No. EC155-31-023

SERVICE BULLETIN

INDICATING AND RECORDING SYSTEMS - VEMD AND CAD VEMD and CAD obsolescence

Corresponds to modifications 0739C92 and MC39C93

Figure 1

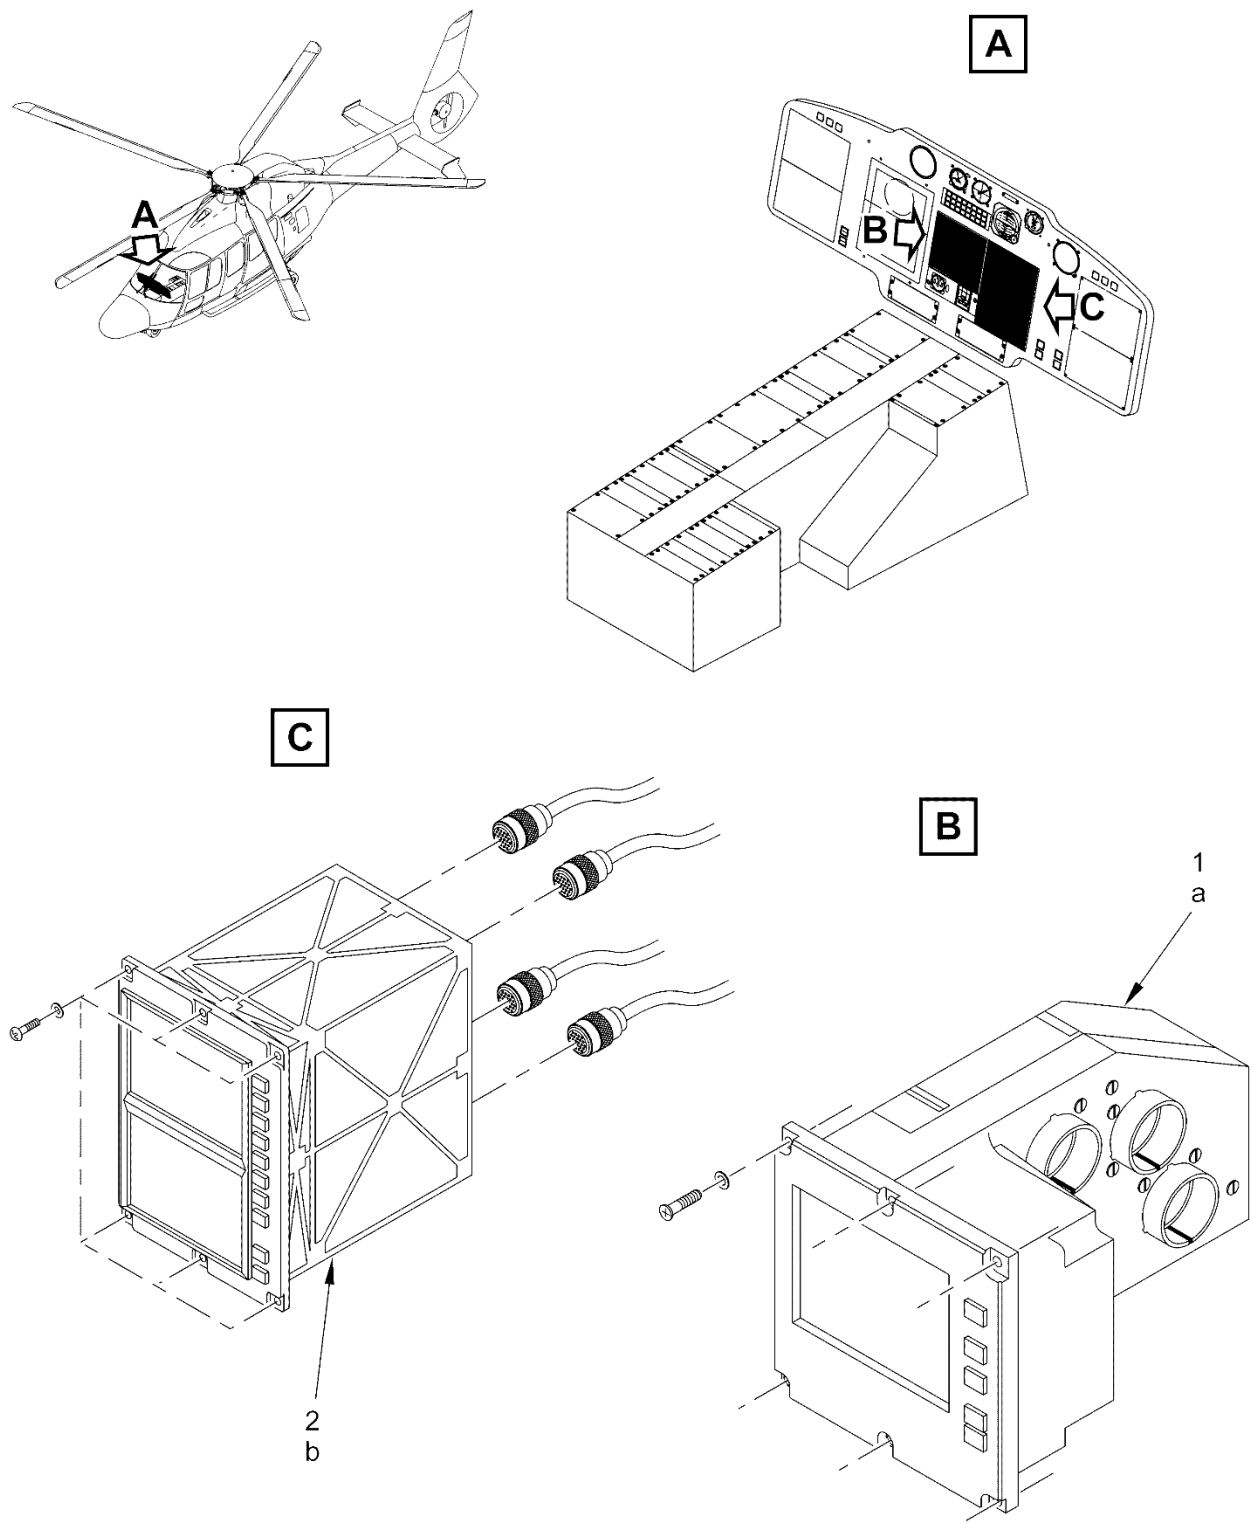
- Remove the concerned VEMD (a) and the configured CAD (b) as per Task 31-60-01-061 (AMM) and Task 31-51-01-061 (AMM).
- Return the VEMD (a) and the CAD (b) as per paragraph [2.D.](#)
- Install the VEMD (1) and the configured CAD (2) as per Task 31-60-01-061 (AMM) and Task 31-51-01-061 (AMM).
